# SERVICE BULLETIN

SERVICE BULLETIN NO: 30-001

## ICE AND RAIN PROTECTION - PITOT-STATIC AND AOA ANTI-ICE SYSTEM STATIC-PORT HEATER WIRES - INSPECTION

Inspection  
Figure 1

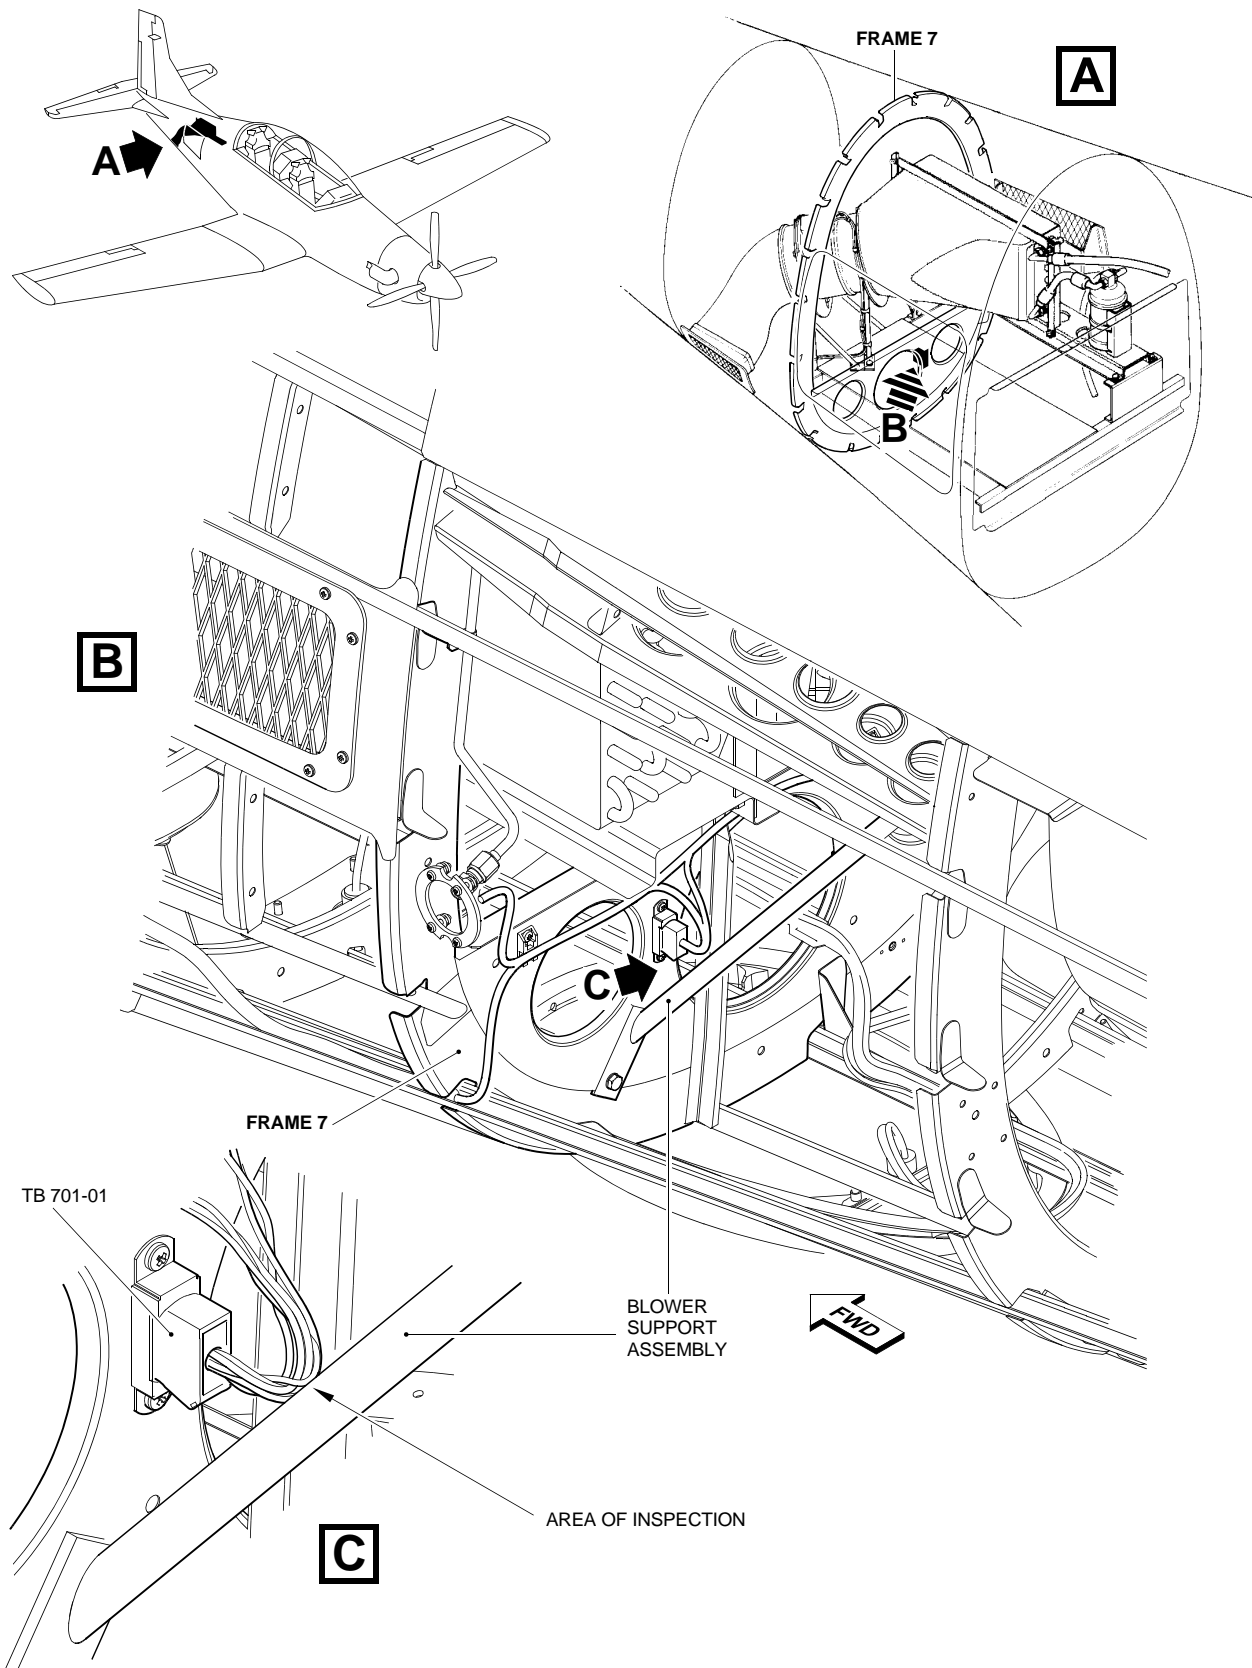
An operator has reported a failure of the static-port heating.

Chafing of electrical wires against a support strut for the condenser fan.

**B. Inspection (Ref. Fig. 1)**

- (1) Examine the wires connected to TB701-01 to see if they can touch the support-strut for the condenser blower motor:

(a) If the wires do not touch the strut, and you cannot move them to make them touch, no further action is necessary. Continue the procedure at Para. C. Test.

(b) If the wires touch the strut, or if you can move them to make them touch:

(i) Use a bright light source and X10 magnifier to examine the wires for chafing or burning.

(ii) If you find signs of melting, burning or the insulation is worn so that you can see the metal wire inside, you must replace the wire(s). Obey the safety precautions given in AMM 24-00-00, Page Block 201.

(iii) Apply glass-fiber tape (Material No. P09-020) around the support-strut where the wires can touch.

(iv) If possible, attach the wires to the support-strut with cable ties (Material No. P09-008) to prevent movement. Do not do this if it puts strain on the wires.
